Seismic Walkdown Checklist (SWC)

Equipment ID No. 1-1808-Q3-L47 Equip. Class¹² 14 (DISTRIBUTION PANELS & AUTOMATIC TRANSFER SWITCHES)
 Equipment Description EMERGENCY LTG DIST PANEL IN LPA7
 Location: Bldg. DG Floor El. 220' Room, Area R101
 Manufacturer, Model, Etc. (optional but recommended) _____

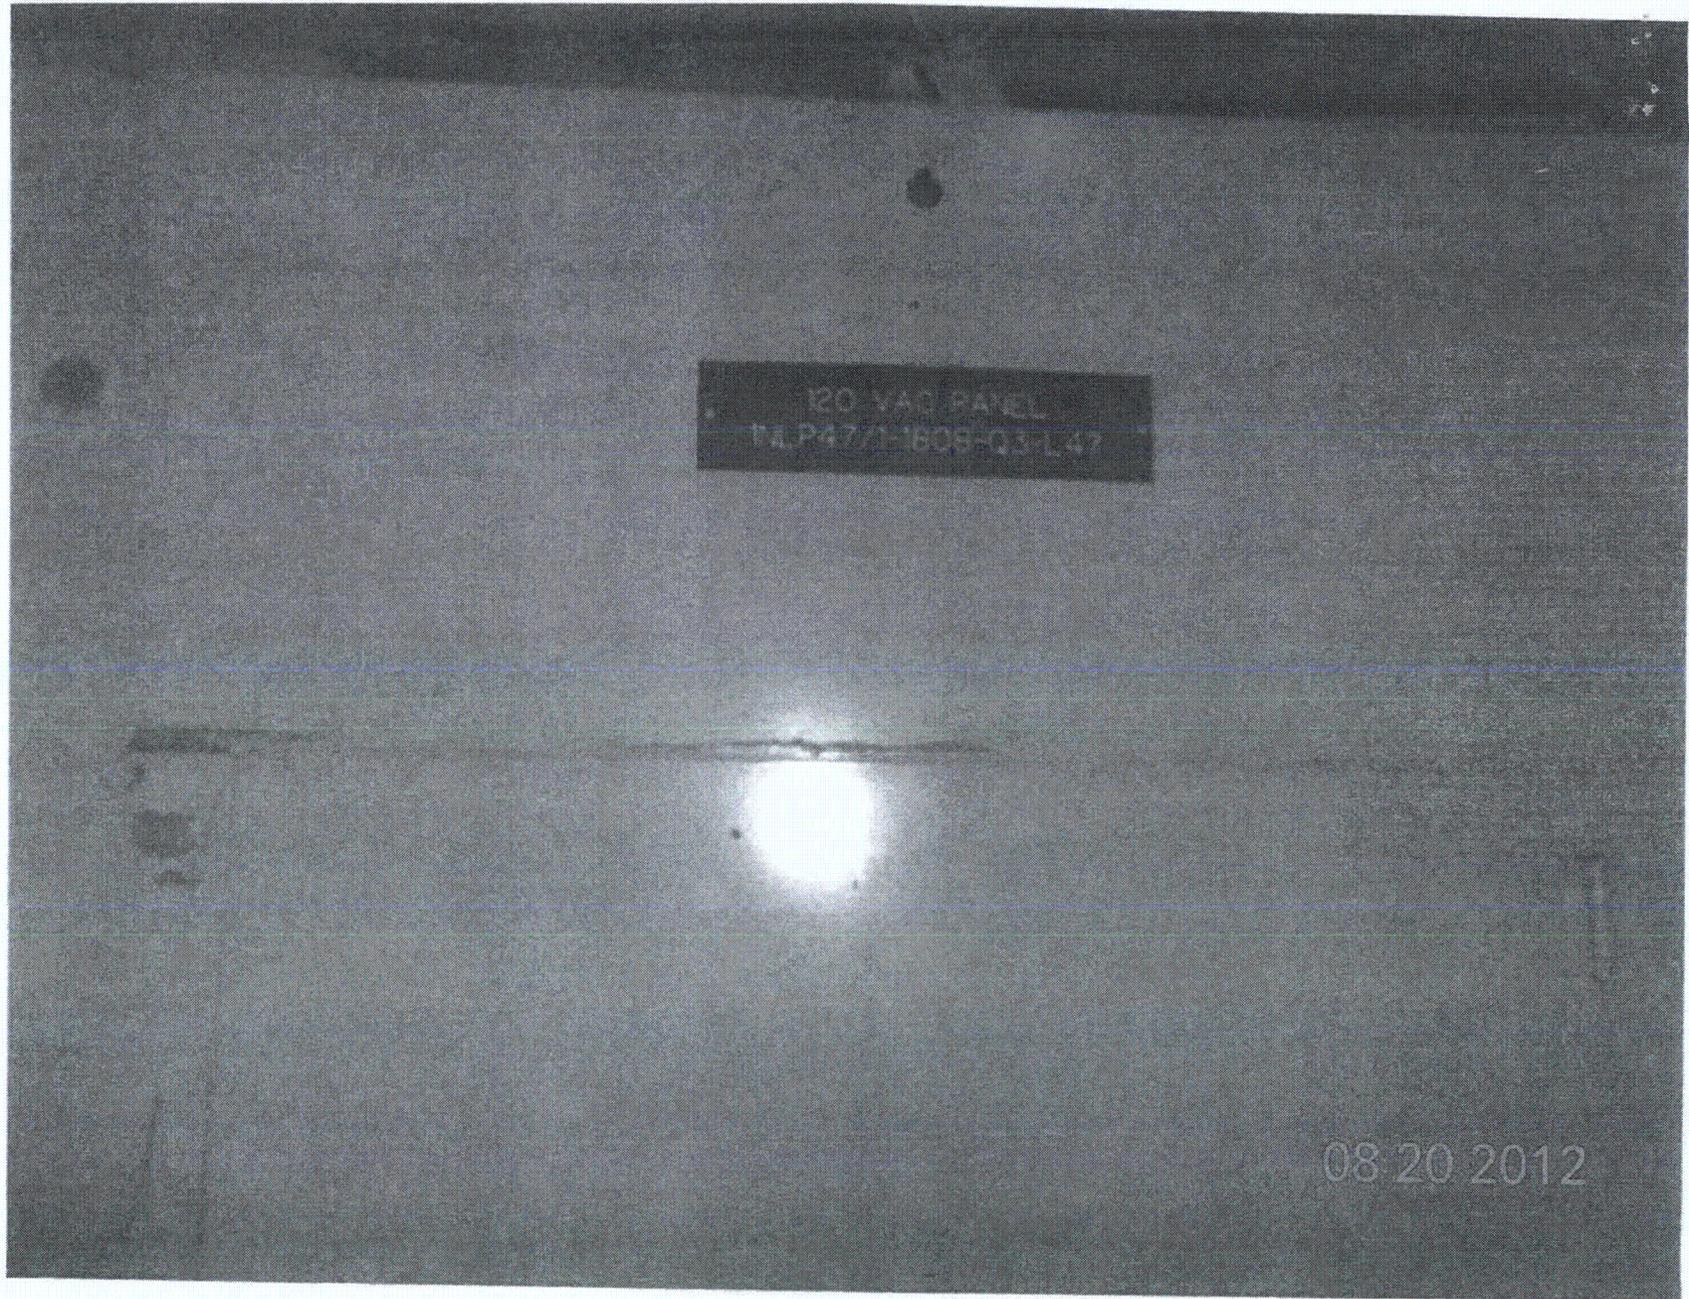
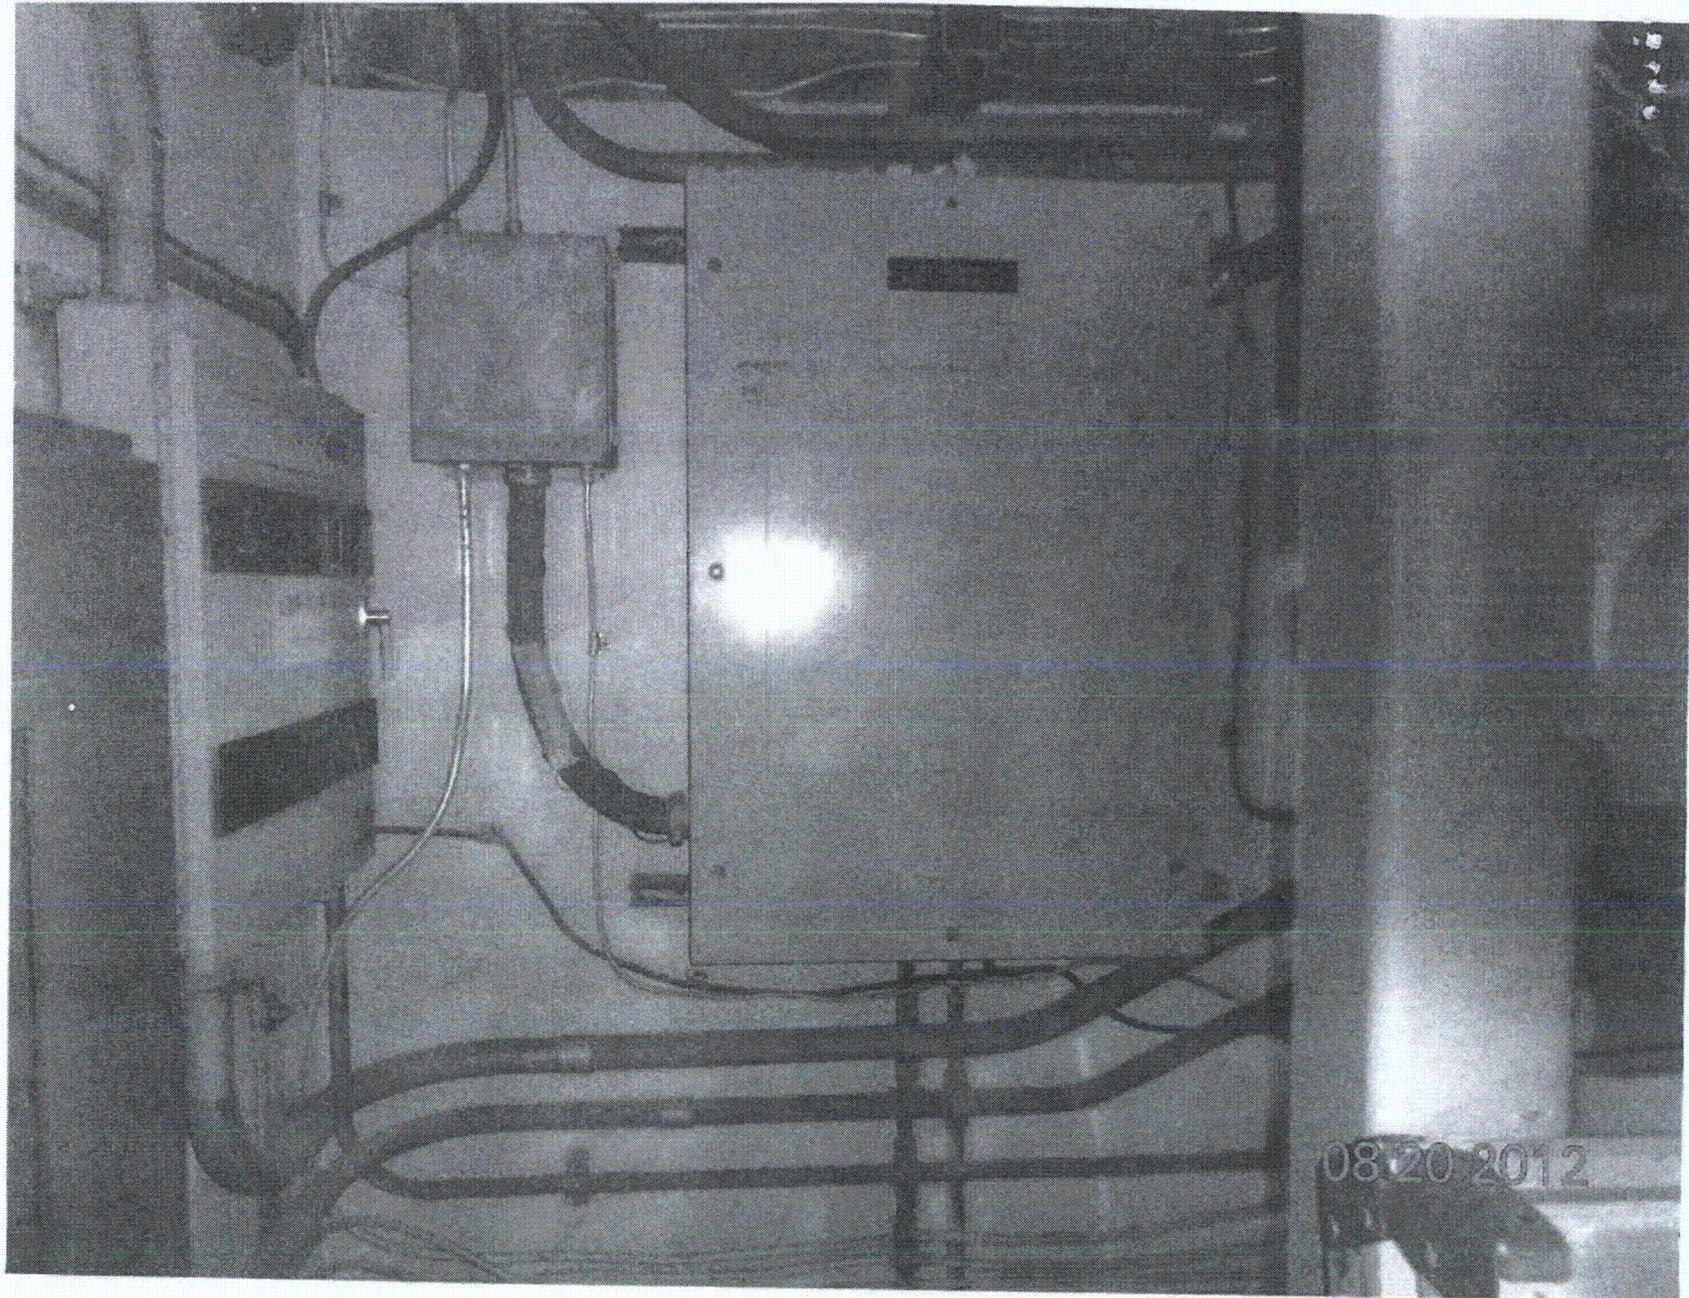
5. Is the anchorage configuration consistent with plant documentation? Y N U N/A
 (Note: This question only applies if the item is one of the 50% for which an anchorage configuration verification is required.)
1 X3A FOI-201, VER. 5.0
PANEL IS ATTACHED TO P1001 UNISTRUTS (TOP & BOTTOM).
EACH UNISTRUT HAS TWO (2) 3/8" ANCHOR BOLTS. REFER TO CR 504874

Equipment ID No. 1-1808-T3-115 Equip. Class¹² 4

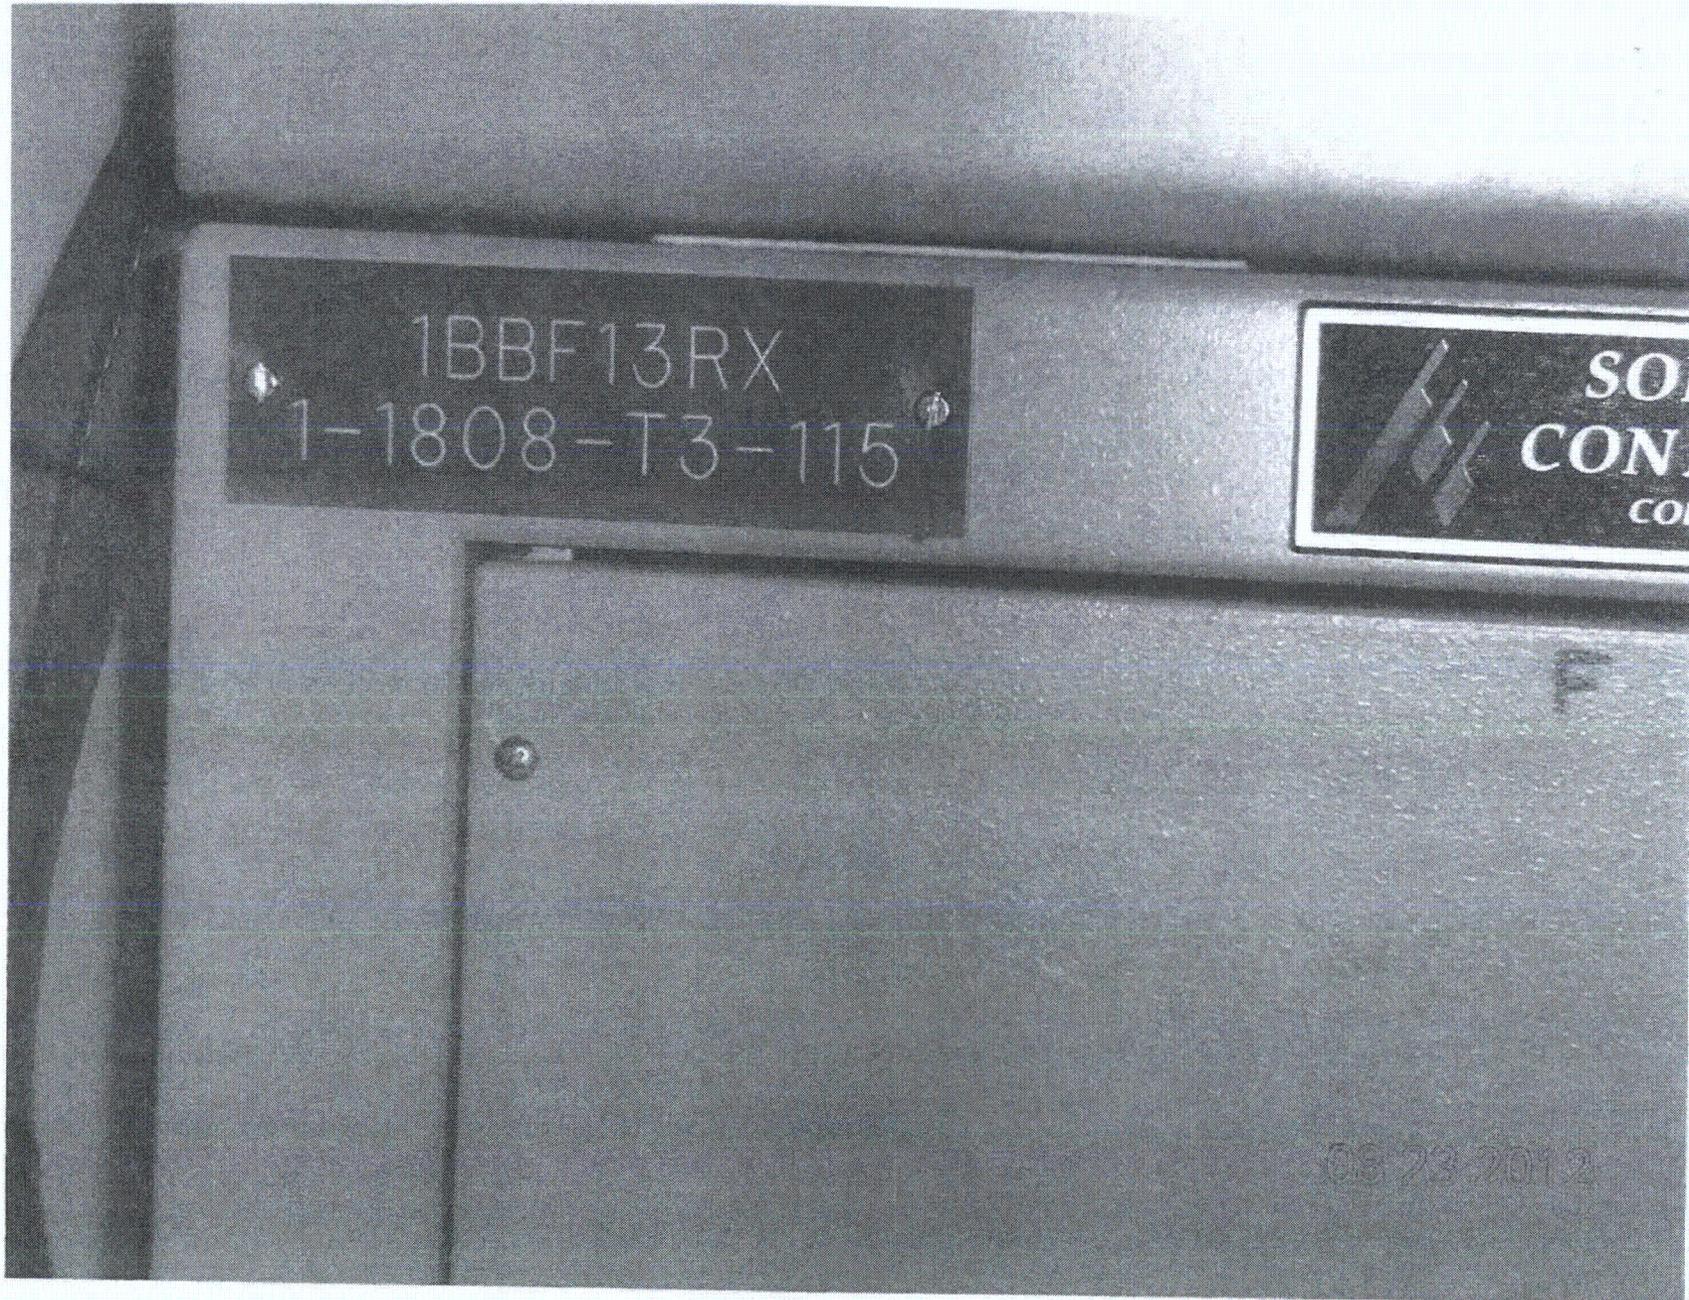
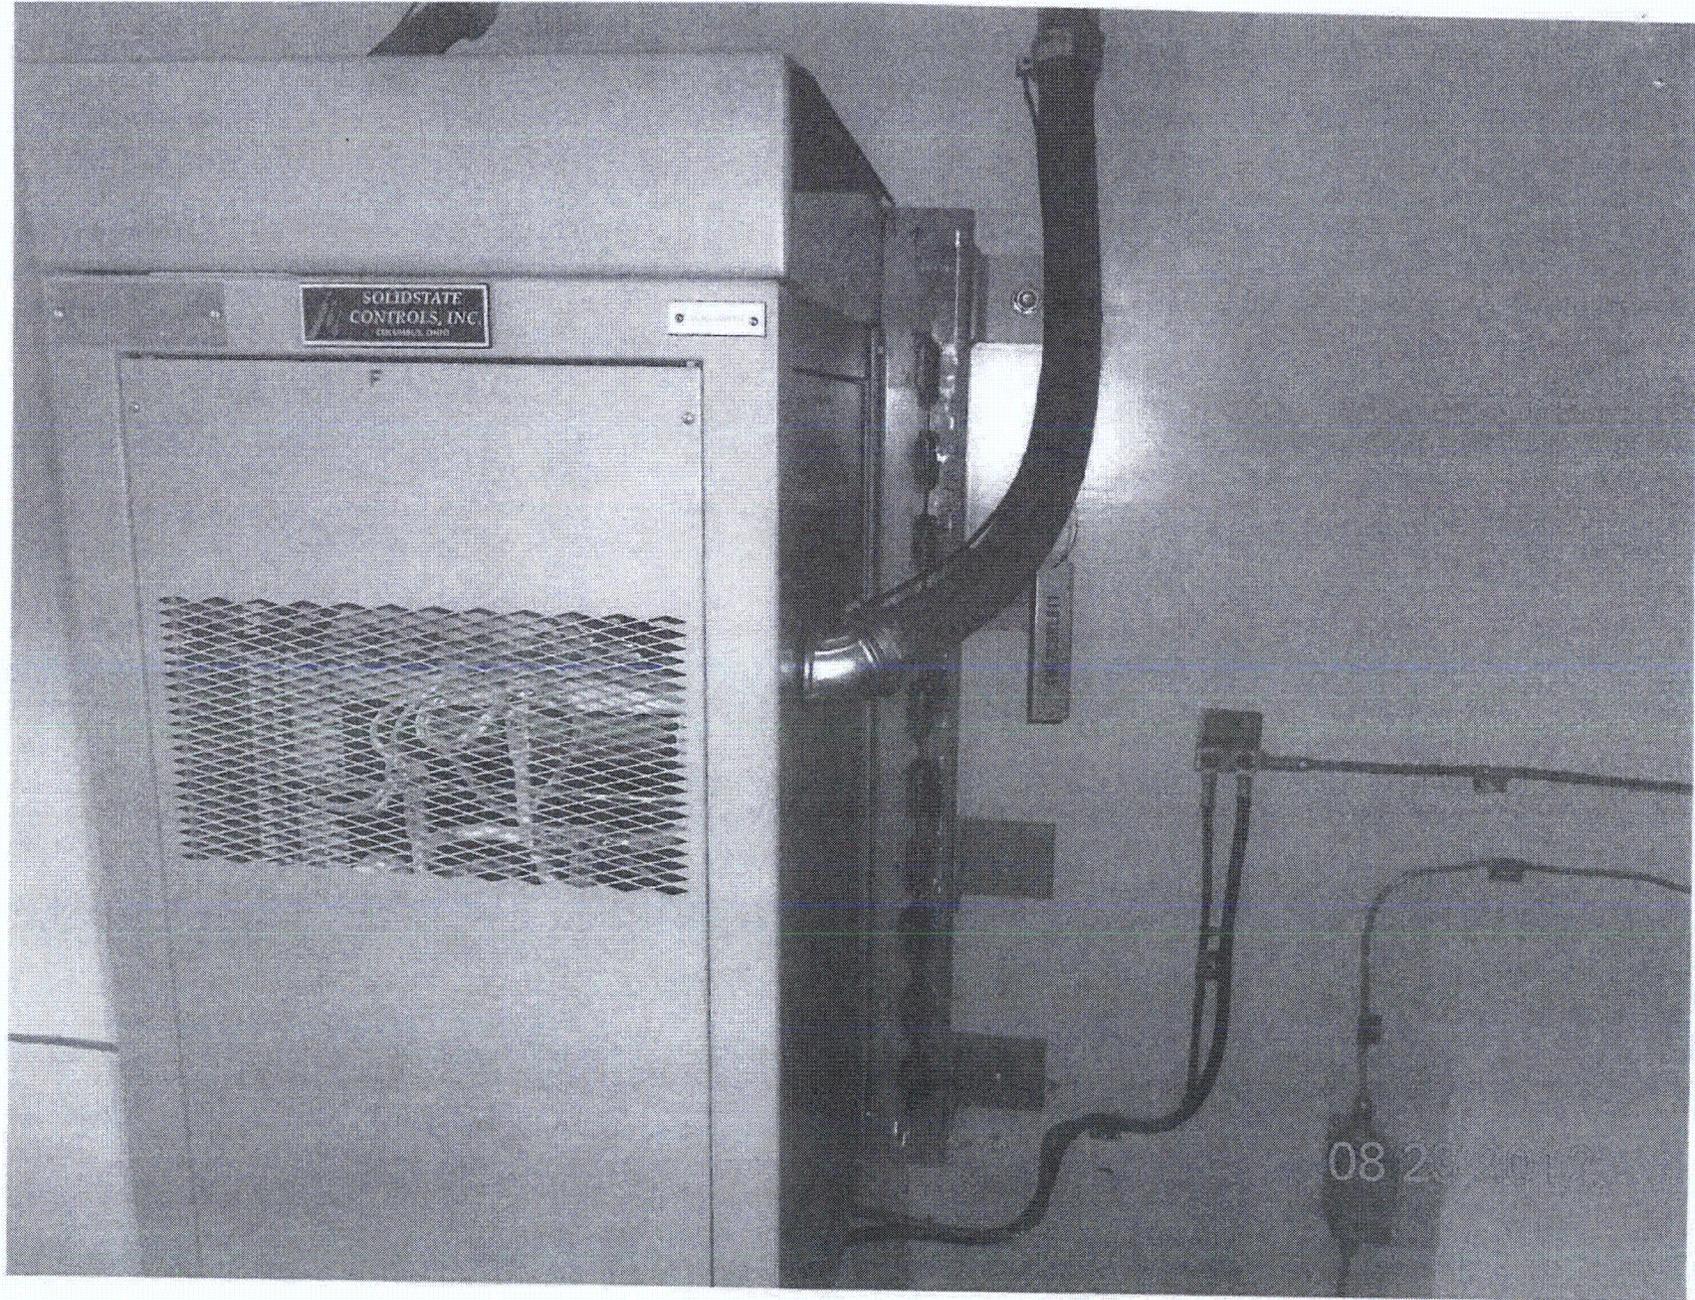
DV
8-23-2012 ~~ALONE~~ THIS COMPONENT HAS BEEN INSPECTED TO THE EXTENT PRACTICAL. THE ANCHORAGE FOR THIS ITEM IS VISIBLE WITHOUT OPENING THE COMPONENT. ALL VISIBLE ANCHORS, HARDWARE AND SURFACES WERE INSPECTED. TO INSPECT THE COMPONENT FURTHER WOULD REQUIRE DISASSEMBLY. SINCE THE ANCHORAGE IS VISIBLE, THE INSPECTION MEETS THE REQUIREMENTS OF THE GUIDANCE DOCUMENT.
